TECHNICAL QUERY
Hollandse Kust Noord

No. TQ :	CW-BALL-TQ-0007	Rev:	A

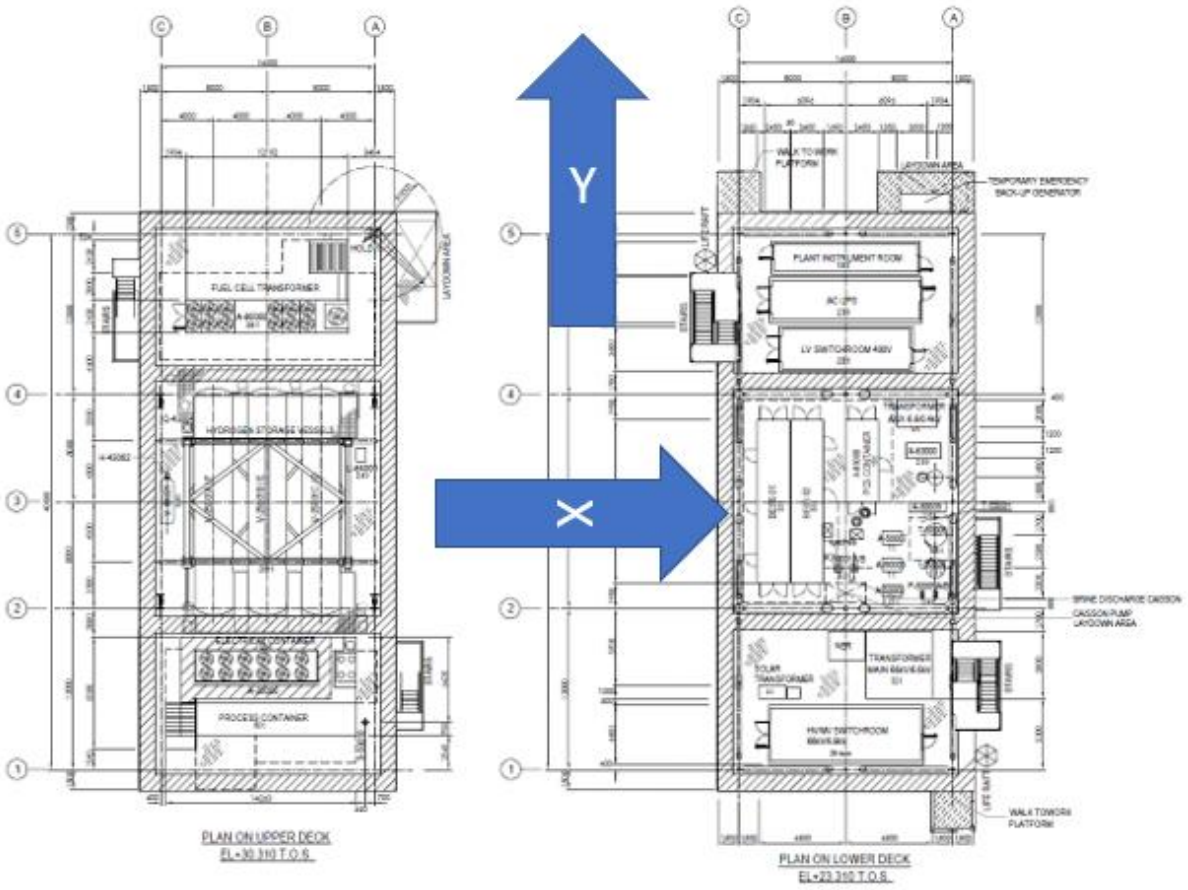
The plot below shows the main axis as used in the table, X corresponds with roll and sway accelerations and Y with pitch and surge accelerations.

Contractor to confirm that this is implemented in their package design and advise on any external seafastening requirement.

CLOSED.

Confirmed via Ballard General arrangement.
